In the Matter of the Capital Plan)
Compliance Docket for Kansas City)
Power & Light Company and Westar) Docket No. 19-KCPE-096-CPL
Energy, Inc. Pursuant to the)
Commission's Order in Docket No.)
18-KCPE-095-MER.)

**SIERRA CLUB'S COMMENTS ON EVERGY'S 2022
INTEGRATED RESOURCE PLAN ANNUAL UPDATE**

PUBLIC VERSION

Figure 2: Capacity Position in Evergy’s New Preferred Plan (CDAAA)¹⁹

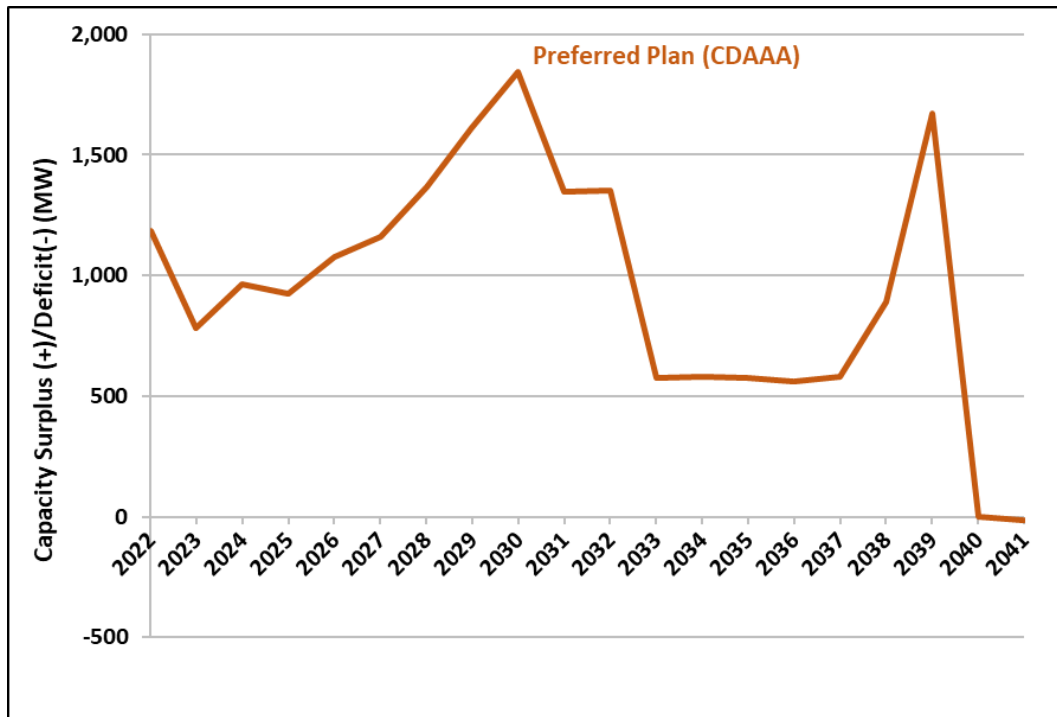
Further, the Company’s preferred plan (CDAAA) leaves it with significant headroom to retire additional coal units without the need for replacement in this decade. Evergy’s 2022 IRP Annual Update¹⁸ shows that the Company’s joint system would be massively overbuilt with the total capacity of its new preferred plan (CDAAA) exceeding its total capacity need by as much as 1,845 MW in 2030, as shown in Figure 2.

Figure 3: Capacity Position in Evergy’s New Preferred Plan (CDAAA)²⁰ w/ Early Coal Retirements

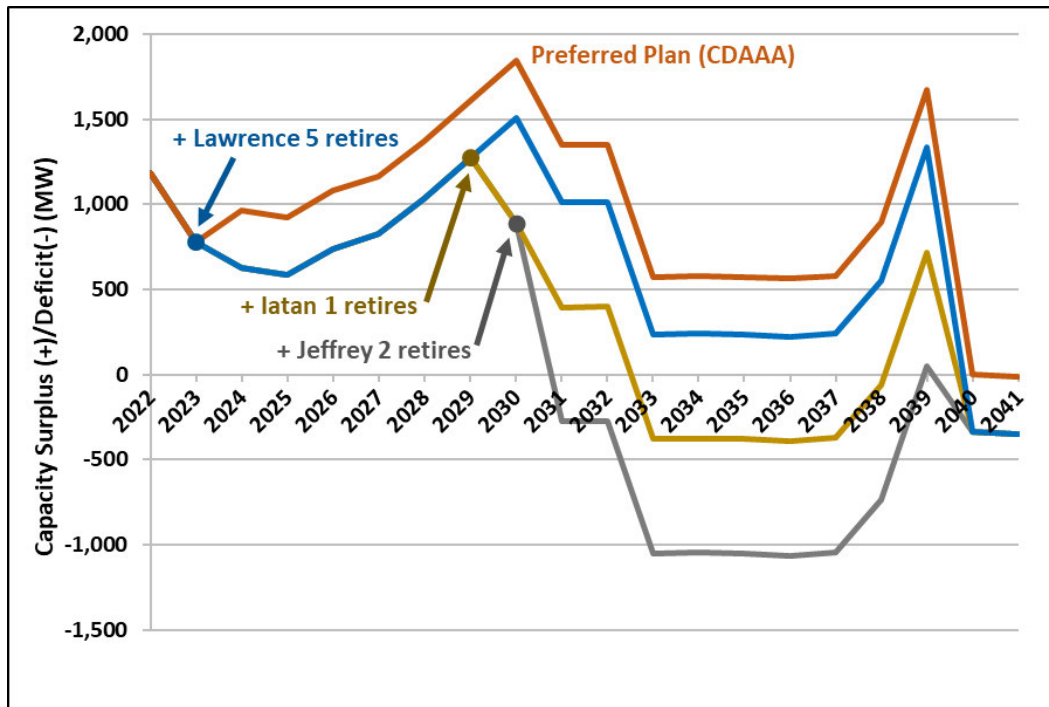
This amount of excess capacity in Evergy’s preferred plan (CDAAA) could allow the Company to retire more units earlier without experiencing a shortfall in capacity until 2031. For illustrative purposes below, we assessed the impact of retiring Lawrence 5 in 2023 instead of converting the unit to gas (shown in blue in Figure 3), retiring Iatan 1 in 2029 (see yellow line), and retiring Jeffrey 2 in 2030 (see gray line) in addition to those retirements in the new preferred plan. The retirement of Lawrence 5 was modeled in the Company’s 2021 triennial IRP—and part of its original preferred plan in that filing—and the latter two units’ retirements were modeled in Evergy’s 2022 Annual Update and were part of lower-cost plans than what the Company chose. These early retirements of Lawrence 5, Iatan 1, and Jeffrey 2 combined do not cause the joint Evergy system to experience a shortfall in capacity until 2031.
